Response to the Reviewers' Comments for JCAS-D-16-00607

Reviewer 2

Figure 1: Time-varying external disturbance simulation

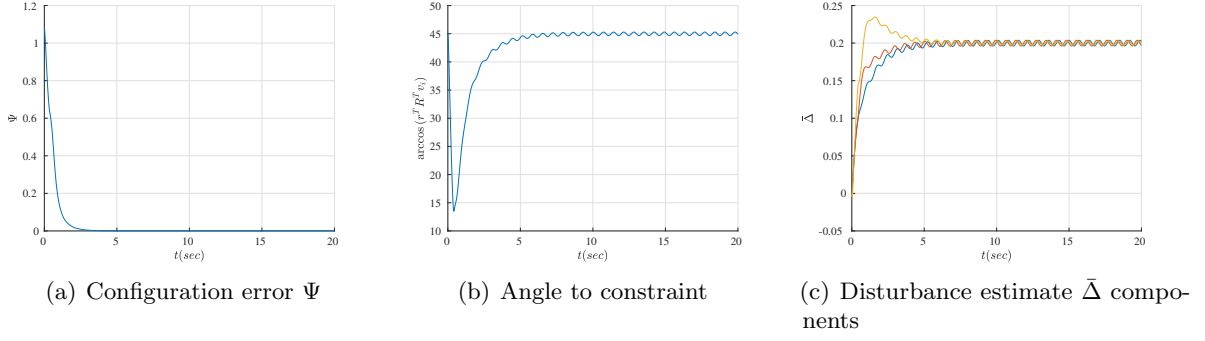
1. *In general, the external disturbance is a time-varying signal even though it is bounded. Thus, authors should consider the time-varying disturbance case.*

It is true that typically, the external disturbances on a system will be time varying. However, the form of uncertainty shown in (1) is commonly used in the adaptive control literature [1, 2]. As a result, we use this same form of uncertainty, namely that the uncertain disturbance is additive in nature and enters through the input channel. In addition, a wide variety of disturbances in the aerospace engineering field are accurately represented by this formulation and several examples are given in the article. Furthermore, it has been shown in [2] that this form of adaptive control is able to handle time-varying uncertainties in which the uncertain term is varying sufficiently slowly as compared to the controlled dynamics. We have improved the manuscript with an additional numerical experiment in ?? demonstrating the ability of the adaptive controller to handle time-varying disturbances. The additional content is duplicated here:

We demonstrate the ability to handle an uncertain time-varying disturbance via numerical example. The system is identical to the one presented in ??, however we modify the external disturbance. The external disturbance is the superposition

of constant and time-varying terms as

$$\Delta = \begin{bmatrix} 0.2 \\ 0.2 \\ 0.2 \end{bmatrix} + 0.02 \begin{bmatrix} \sin 9t \\ \cos 9t \\ \frac{1}{2}(\sin 9t + \cos 9t) \end{bmatrix} \text{ N m.}$$

We define a constraint in the inertial frame as $v = [\frac{1}{\sqrt{2}}, \frac{1}{\sqrt{2}}, 0]^T$ with $\theta = 12^\circ$. The initial state is defined as $R(0) = \exp(\frac{\pi}{2}\hat{e}_3)$, while the desired state is $R_d = I$. The goal is to rotate the vehicle about the e_3 axis while avoiding the obstacle and compensating for the time-varying disturbance.

?? demonstrates the ability for the adaptive controller, which is presented in Proposition ??, to handle time-varying disturbances. ?? shows the non-dimensional value of the configuration error function and demonstrates that the adaptive controller is able to stabilize the system to the desired attitude configuration. In addition, ?? shows that the constraint is never violated as the angle between the body-fixed sensor r and the constraint v is greater than 12° over the entire attitude maneuver. We can see in ?? that that estimate $\bar{\Delta}$ for each of the components, accurately tracks the true disturbance after approximately 5 s.
